ADDENDUM No. 7
LUC SR 2 21.72 NAVARRE SAFETY (PID 118234)

CITY OF OREGON
DEPARTMENT OF PUBLIC SERVICE

Plan holders of the City of Oregon's LUC SR 2 21.72 Navarre Safety Project (PID 118234) are hereby notified of the following amendments to the Contract Documents. The following additions, alterations, deletions and/or clarifications shall be part of the Base Bid as much as if they were originally included in the Contract Documents. This Addendum No. 7 is hereby made a part of the Contract Documents.

Original Navarre Avenue Street Lighting Plans from 1999 LUC-2-21.24 Project

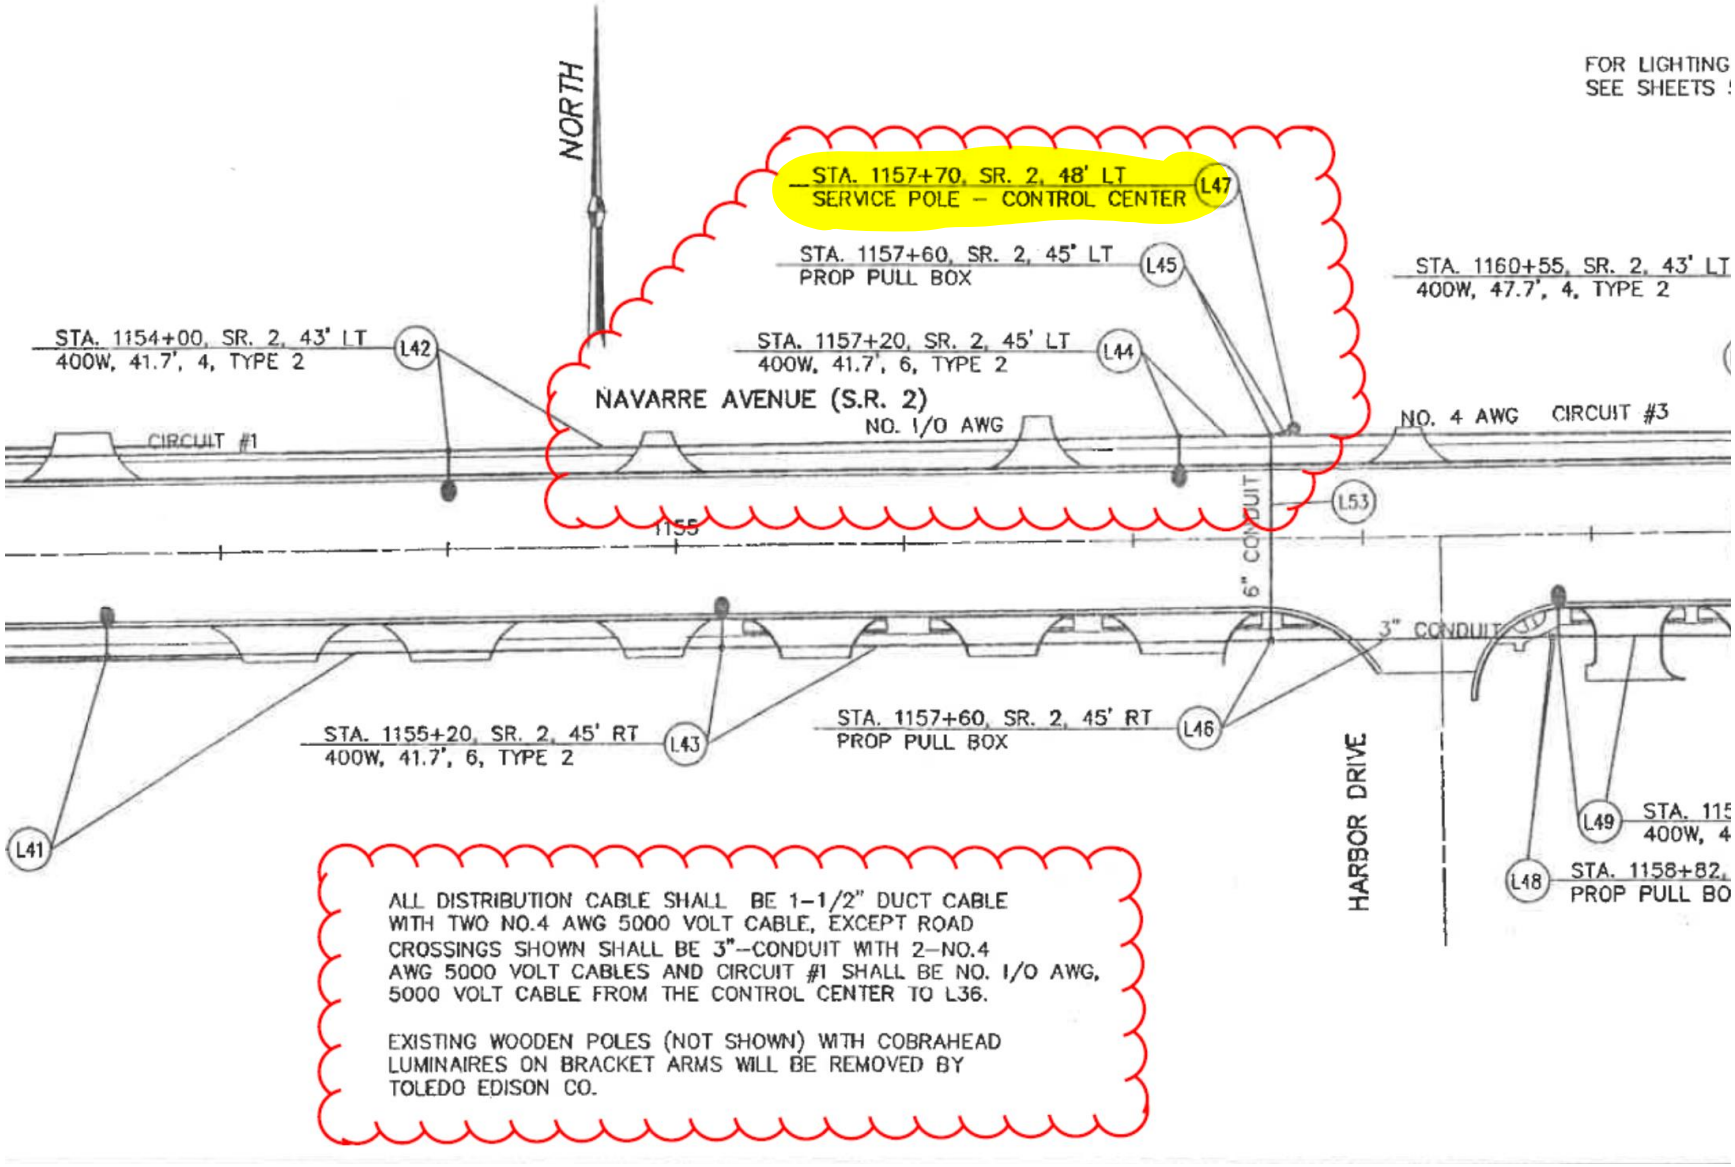
Please refer to the original plan information below regarding the existing street lights, which indicates the lighting wire size, conduit sizes, and general location for the work associated with **Pay Ref 99 – ITEM 625 POWER SERVICE, AS PER PLAN, LIGHTING**. This is in accordance with the revised note included on **REVISED PLAN SHEETS 136** noted **Addendum #7 (Issued 8/7/25)**.

SIGNAL DETAILS
NAVARRE AVENUE (SR-2)/KINGSTON COURT

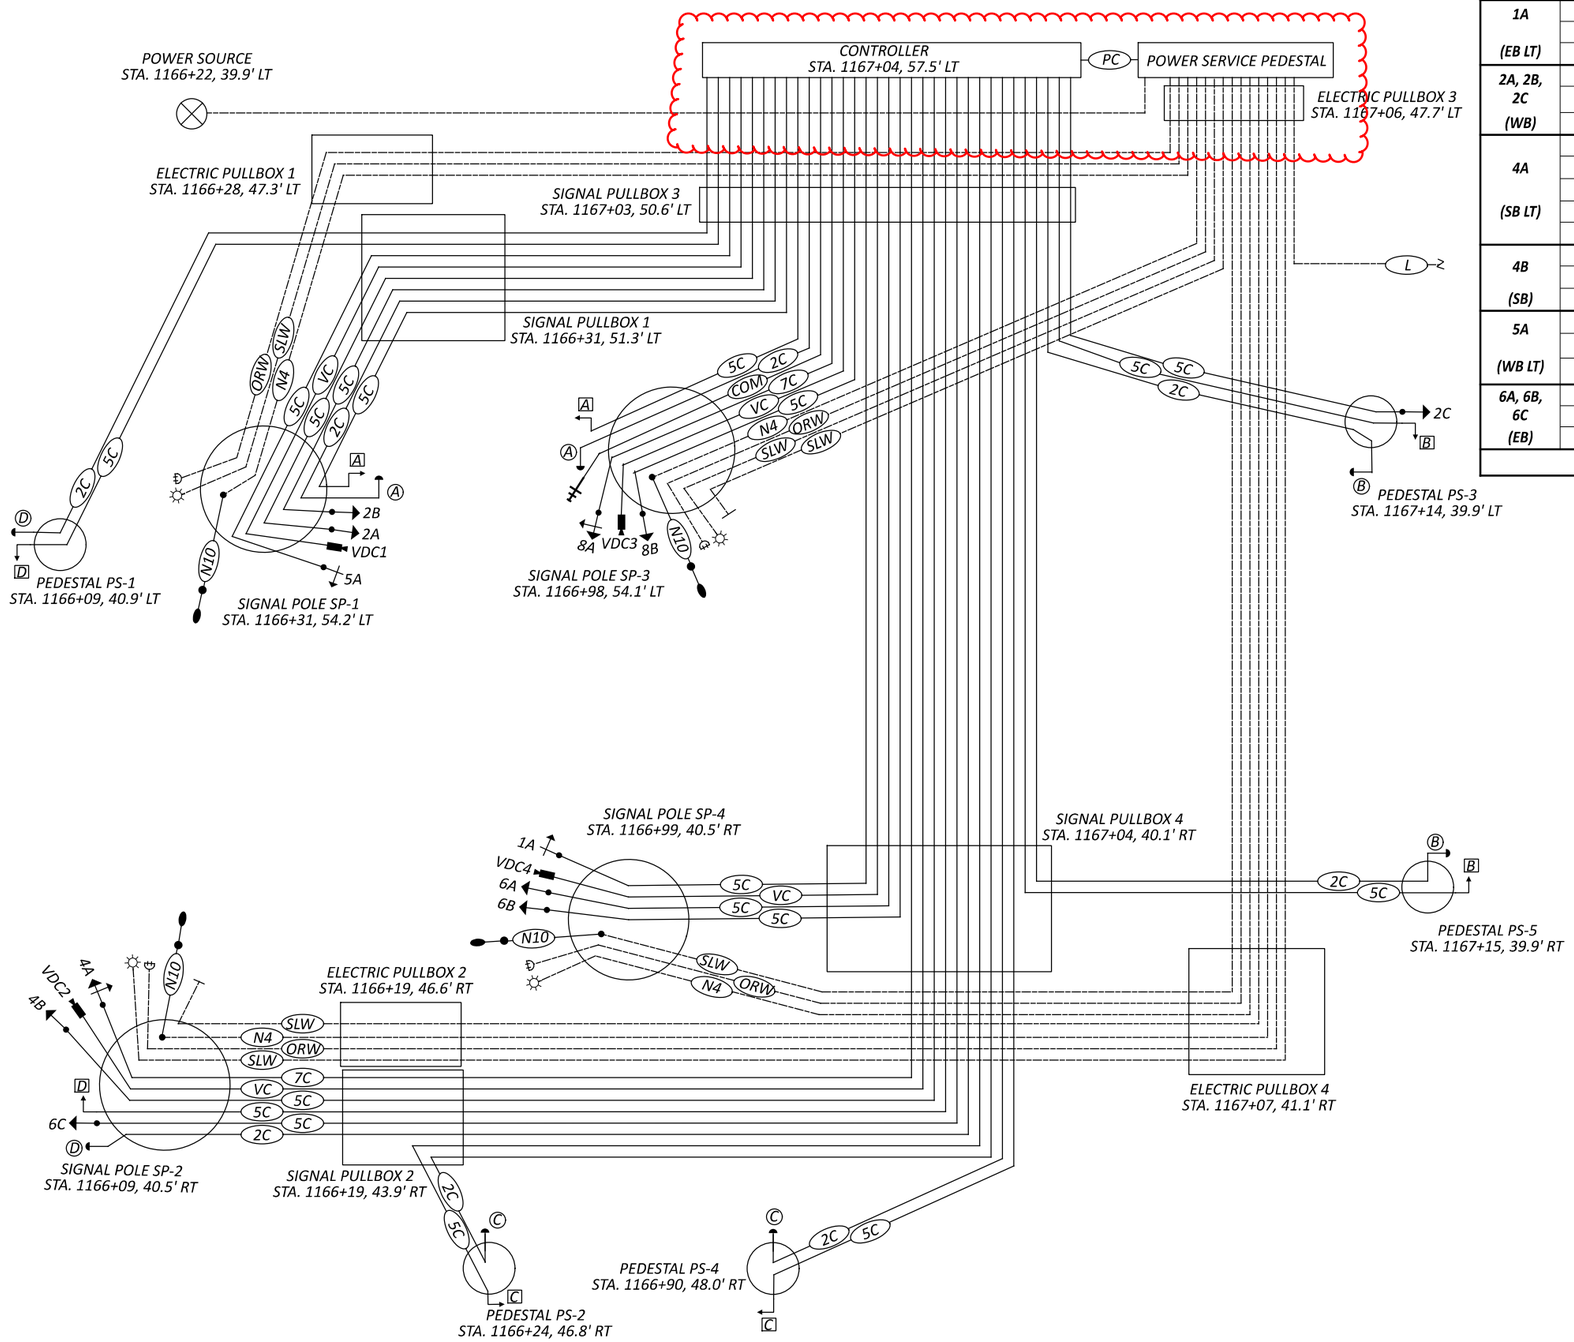
DESIGNER NOTE:
LIGHTED SIGN WIRING HAS BEEN DESIGNED TO RUN FROM THE CABINET TO THE POLE BASE IN SP-2 AND SP-3 FOR FUTURE NO TURN ON RED LED SIGNS.
